Project Number: SP2018-005
Project Name: 615 Highland Drive
Project Type: SITE PLAN
Applicant Name: HUCKABEE
Owner Name: ROCKWALL, I S D
Project Description:

SP2018-005 -SITE PLAN FOR REINHARDT ELEMENTAR SCHOOL
SITE PLAN - LOCATION MAP =

Discuss and consider a request by Crystal Vasquez of Huckabee on behalf Will Salee of the Rockwall Independent School District for the approval of a site plan for a school on a 6.983-acre parcel of land identified as Lot 1, Block A, Rockwall School Addition #2, City of Rockwall, Rockwall County, Texas, zoned Single Family 10 (SF-10) District, addressed as 615 Highland Drive, and take any action necessary.

ARCHITECTURAL EXTERIOR BUILDING MATERIALS

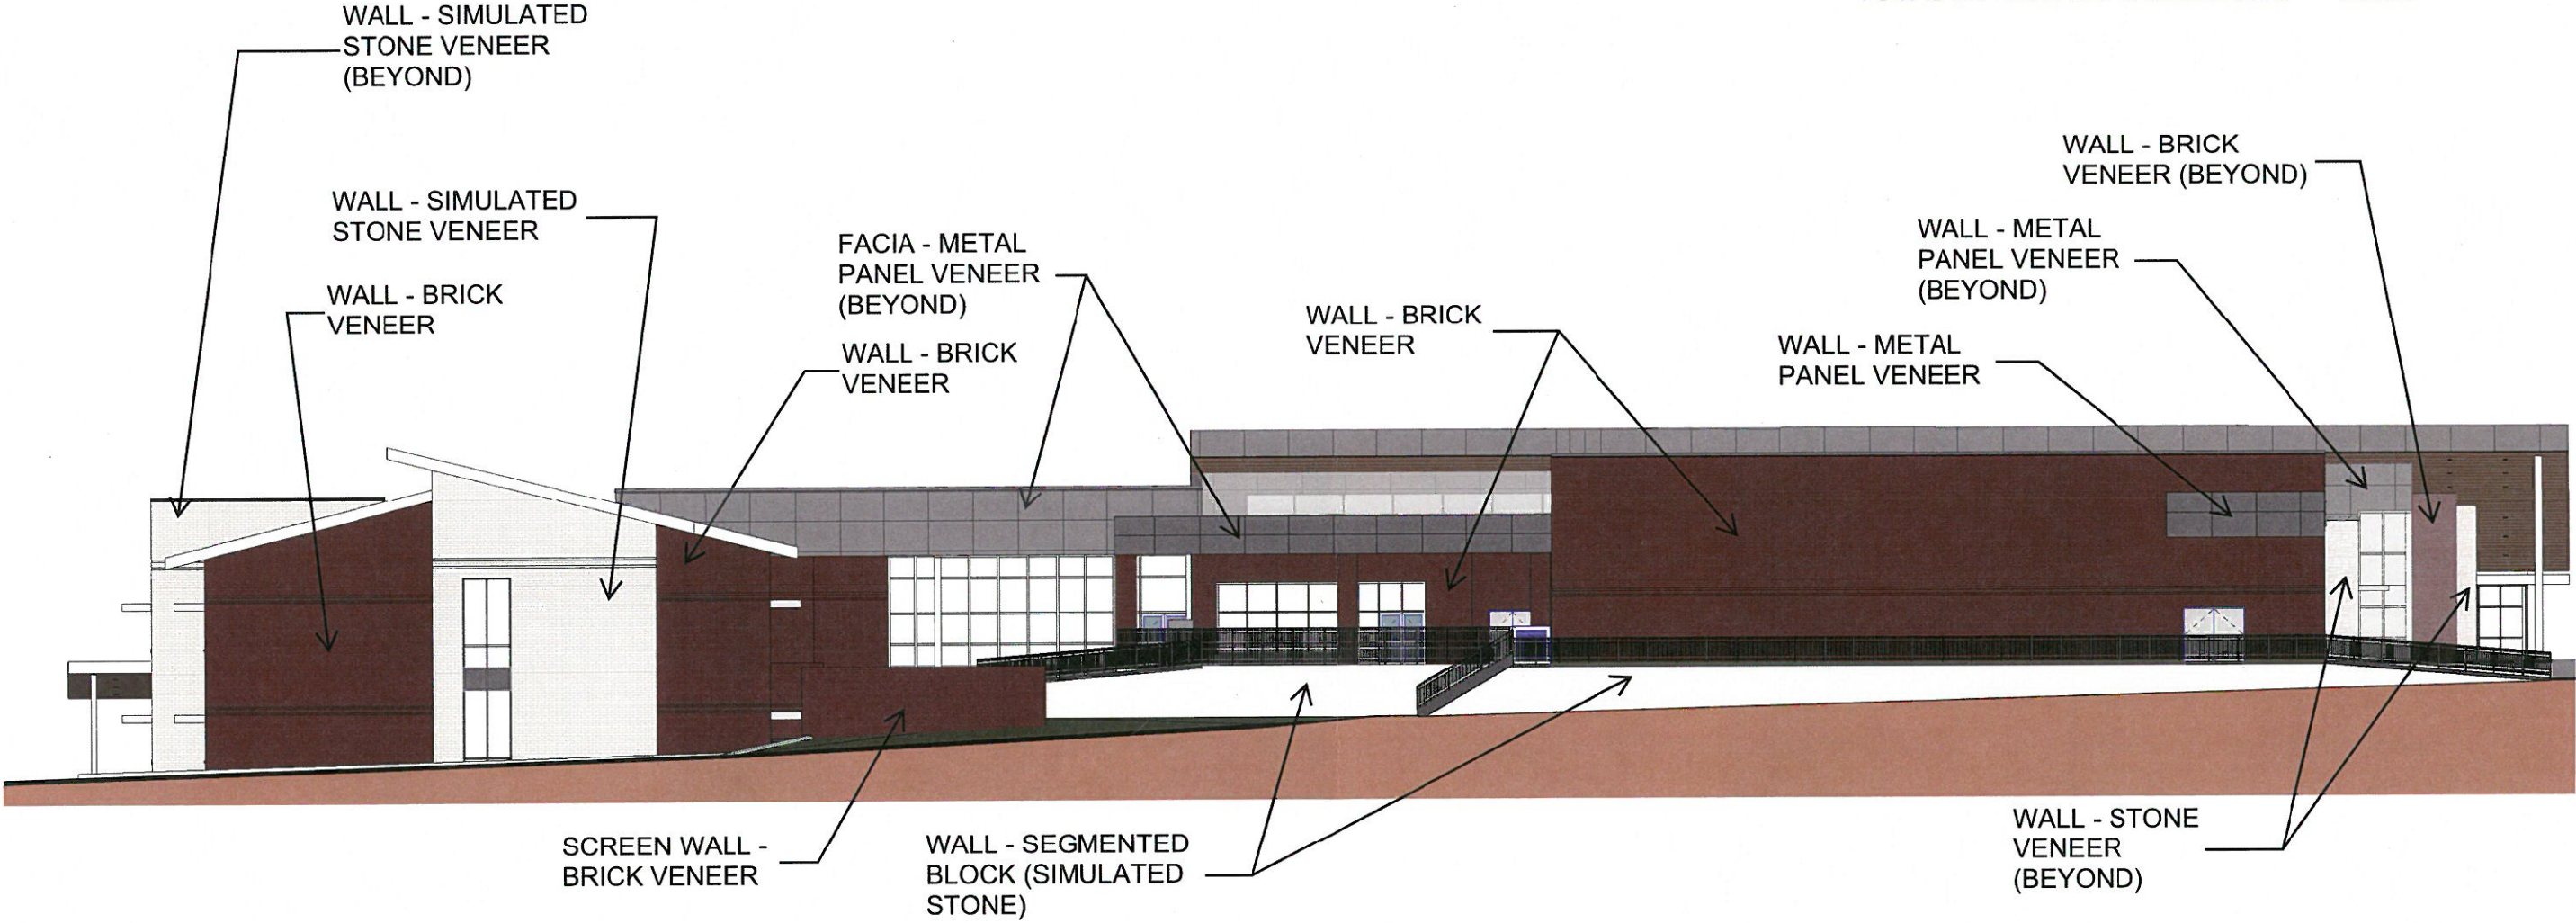
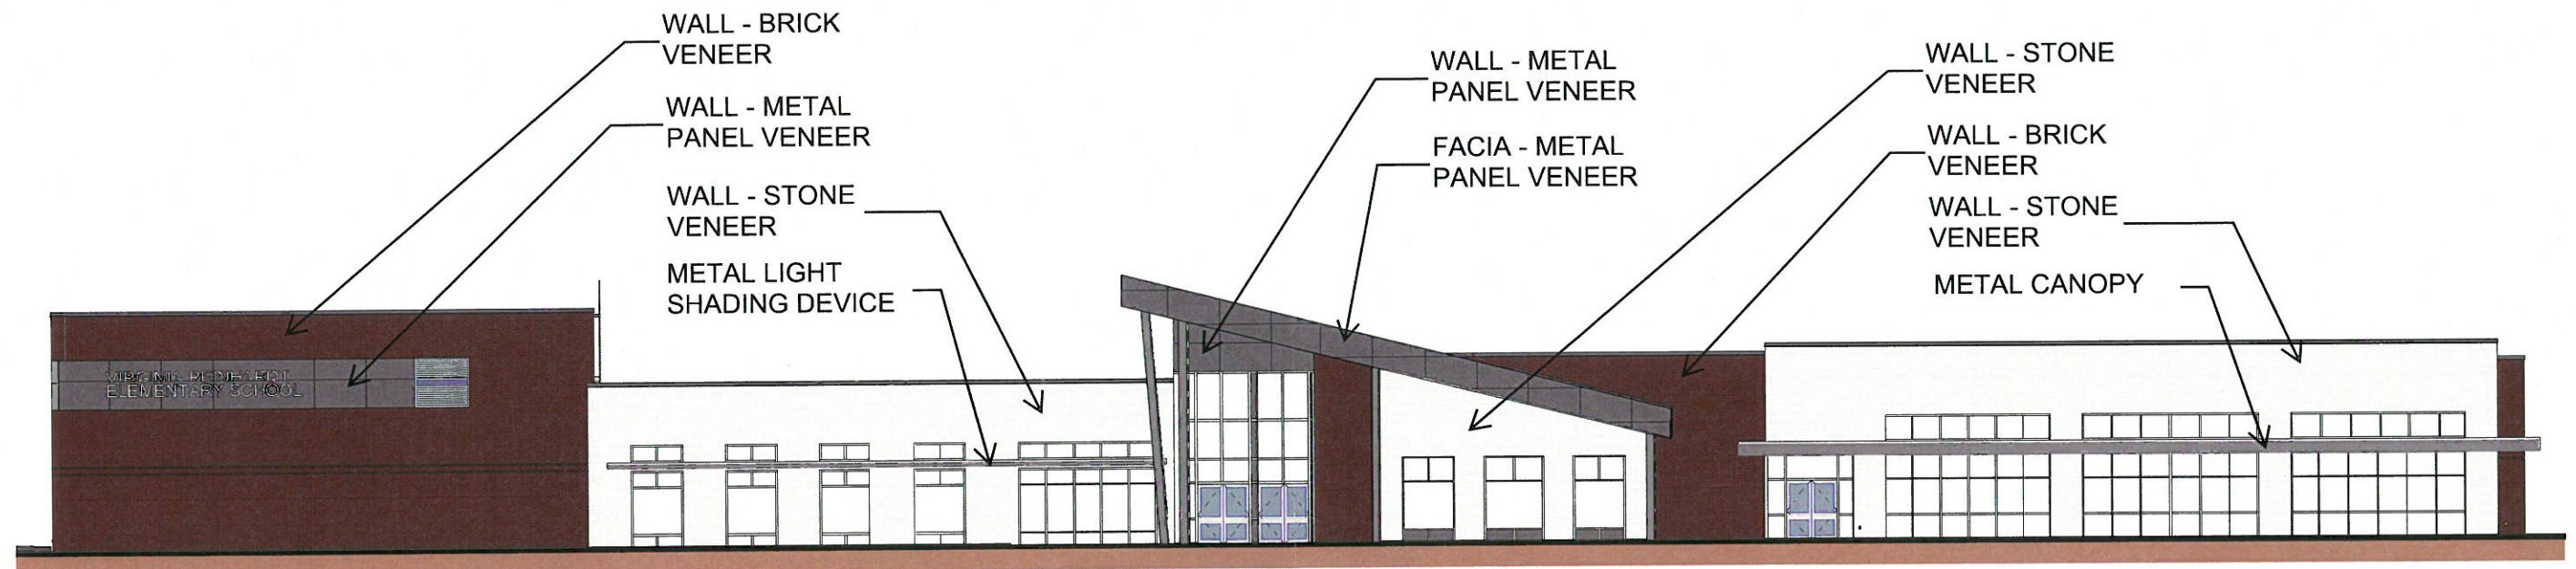
Type of Review / Notes	Contact	Sent	Due	Received	Elapsed Status	Remarks
Building Elevations:						
1. All roof-top mechanical equipment requires screening from rights-of-way and adjacent properties. Provide a roof plan indicating location of units and/or dash-in RTU's on elevations. Provide detail of screening mechanism to be used.

2. Why are there two (2) drawing submitted for the east and west elevations?						
3. The following requires approval of an exception to the masonry standards by the City Council due to the "simulated stone" appearing to be thin brick per the materials sample board submitted and as indicated above:

ELECTRICAL
PHOTOMETRIC SITE PLAN

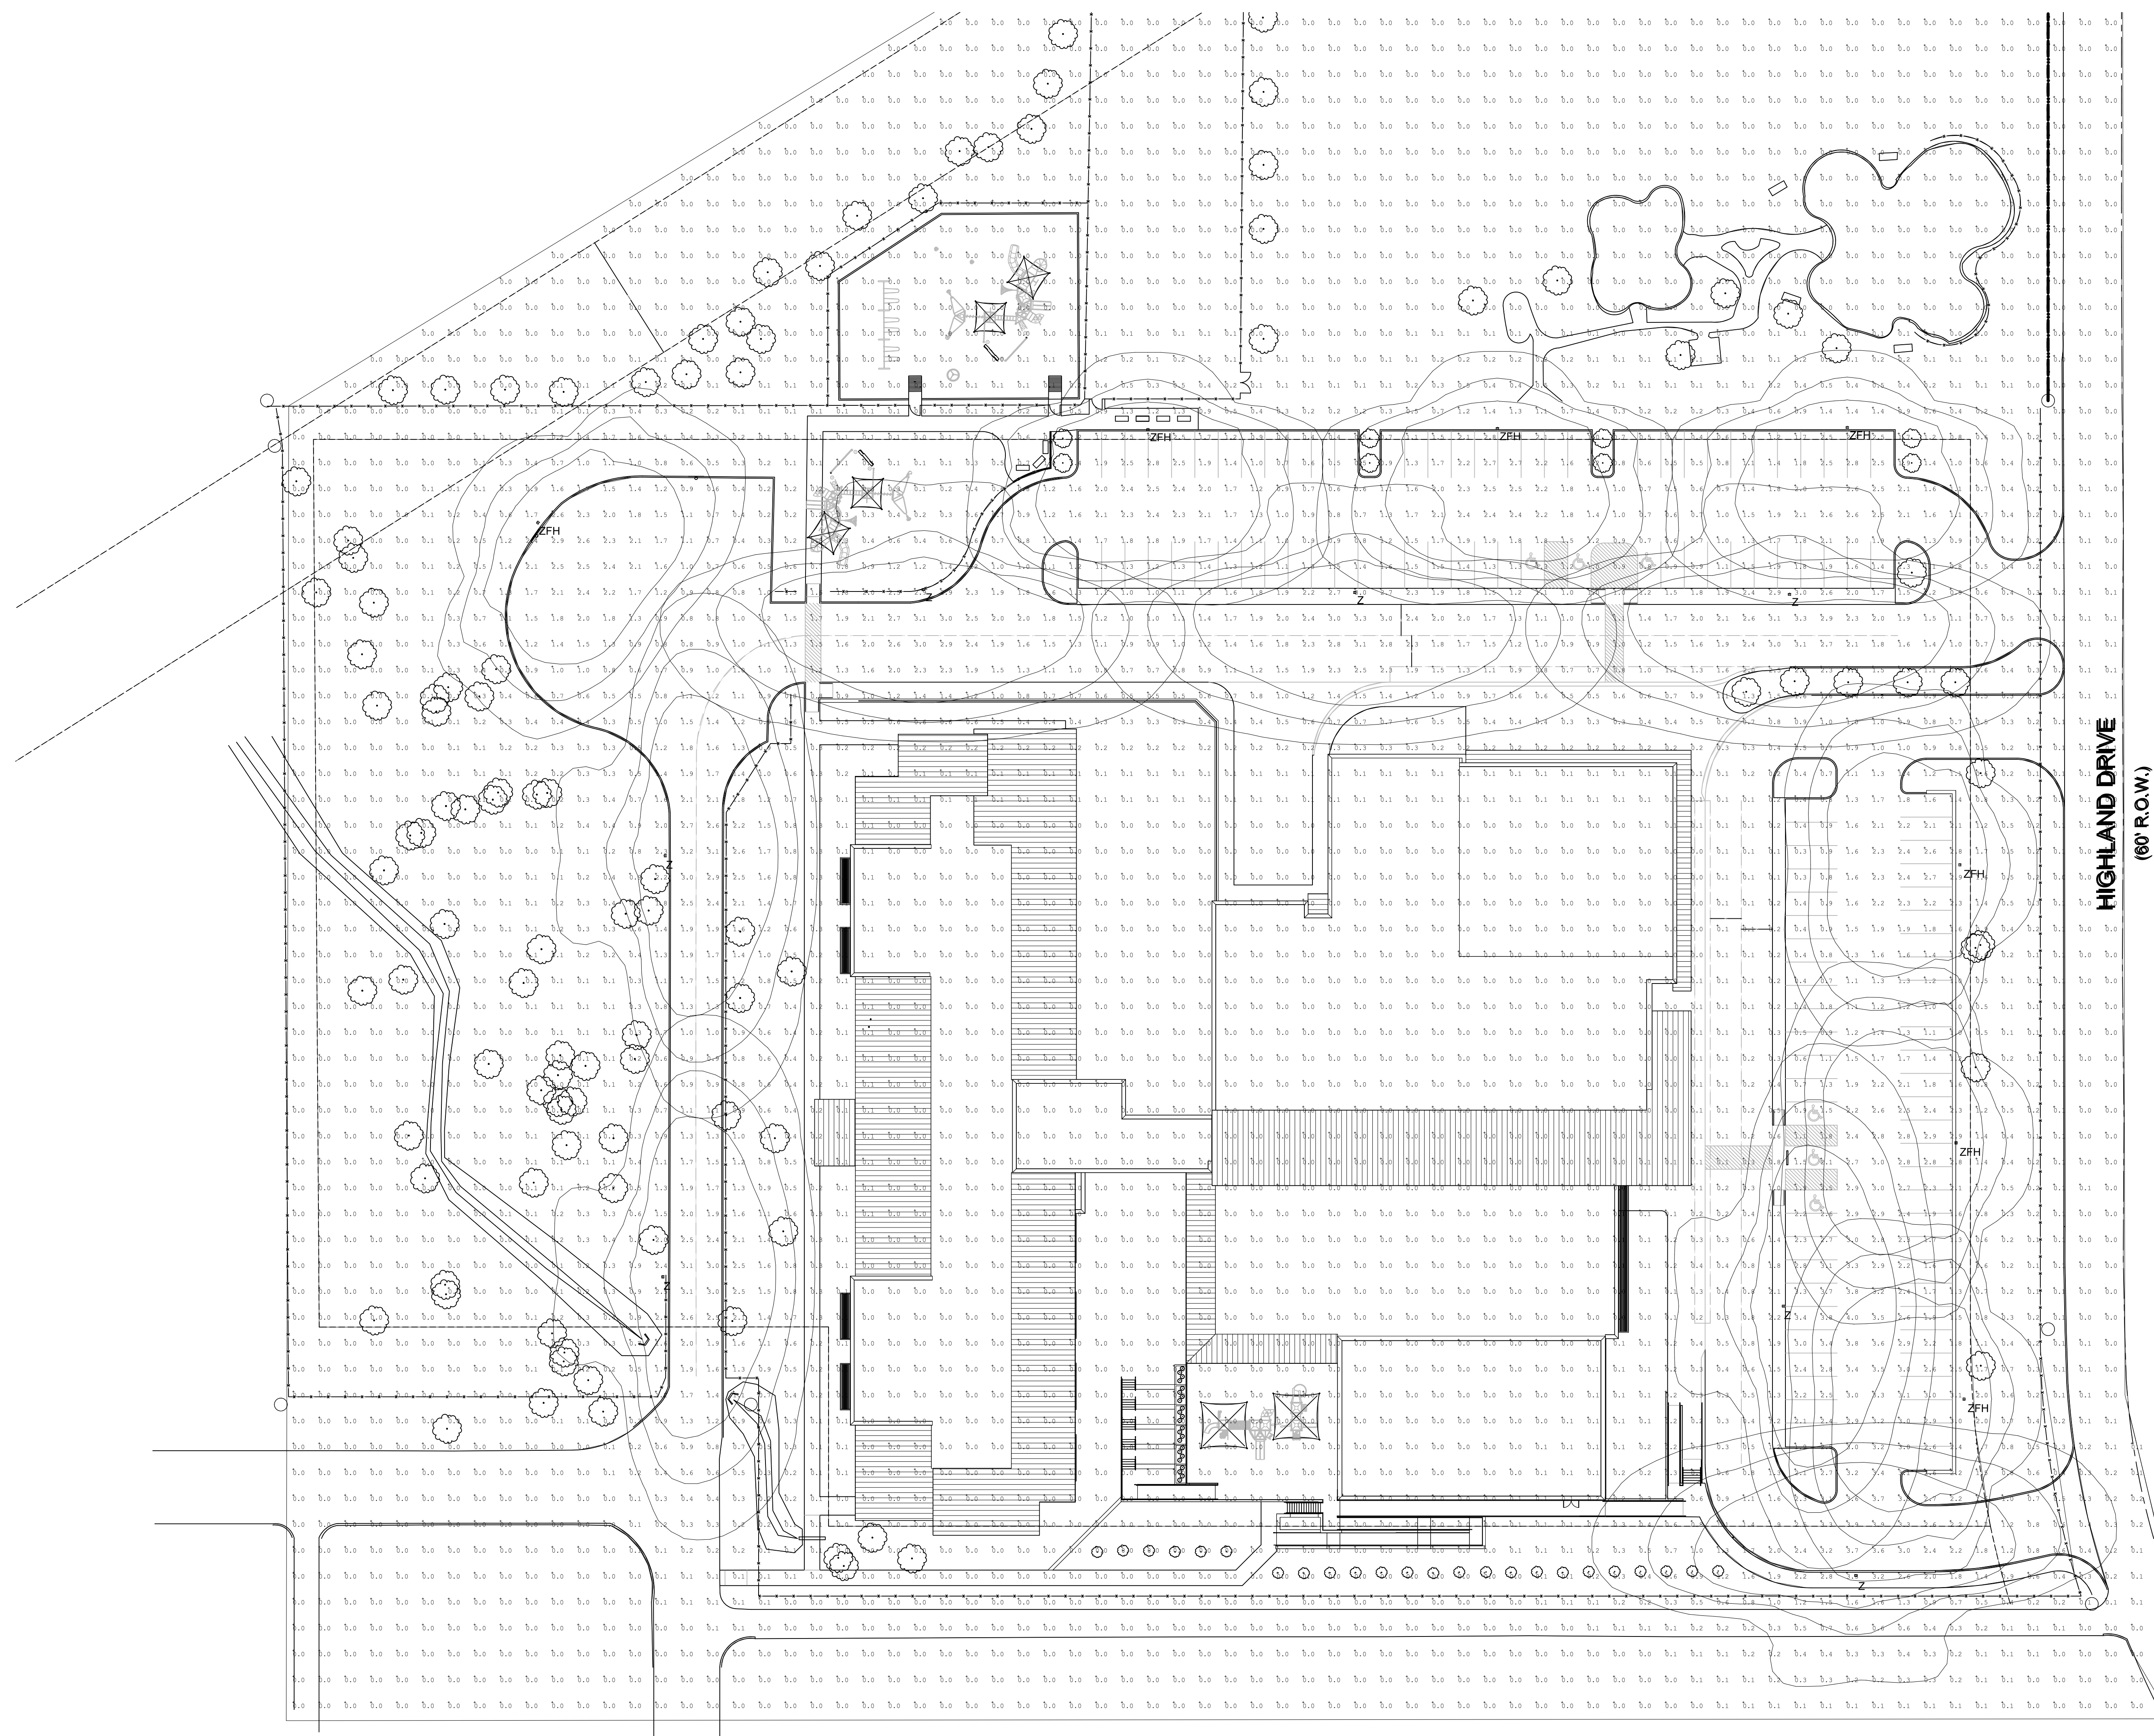
2. How will you satisfy the mitigation balance of 599-caliper inches?						
Photometric Plan:						
1. The lighting pole standards are not to exceed a maximum overall height of 30-ft includes pole, base, fixtures, etc.) per the UDC standards. Provide detail.

2. In order to reduce glare, all exterior lighting fixtures are to be shielded. Provide cut sheets for all exterior light fixtures.						
3. The lighting levels at the southeast and southwest corners of the property exceed 0.2-FC at the property lines. Adjust accordingly.
